**Re: Agnico Eagle Mines – Meliadine Division Response to the Saline Water Treatment Plant Recommendations from CIRNAC**

- Crown-Indigenous Relations and Northern Affairs Canada (CIRNAC) Technical Review Comments on the Design Report for the Saline Water Treatment Plant at Meliadine – Agnico Eagle Mines Limited.

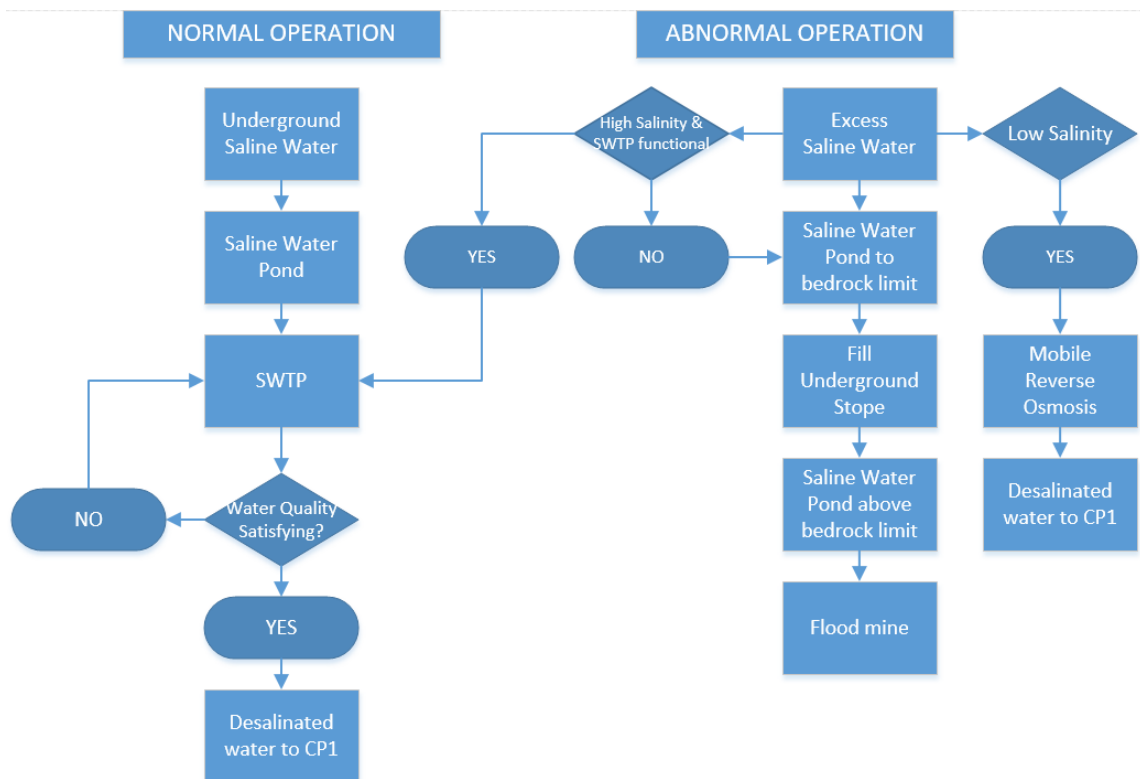
**Comment:** The design report explained the capacity for saline water both in the underground and at surface. However, the design report did not discuss any contingencies.

**Recommendation:** CIRNAC recommends that the design report include contingencies such as, but not limited to, long term breakdown of the treatment plant or inefficiencies of the plant and greater than expected inflows of saline water in the underground workings.

Potential issues could arise during the operation of the Saline Water Treatment Plant (SWTP) and mitigation measures have been implemented to prevent and minimize the risks of releasing non-compliant levels of constituents to the environment. Below is a summary of the two most significant potential issues with their respective contingency plans.

- Underground saline water inflows in the mine:

In case of significantly higher underground saline water inflows in the mine, or of a major malfunction of the SWTP, the following contingency plan for storage has been developed. On the left is presented operations under normal conditions, and on the right are operations under abnormal conditions:
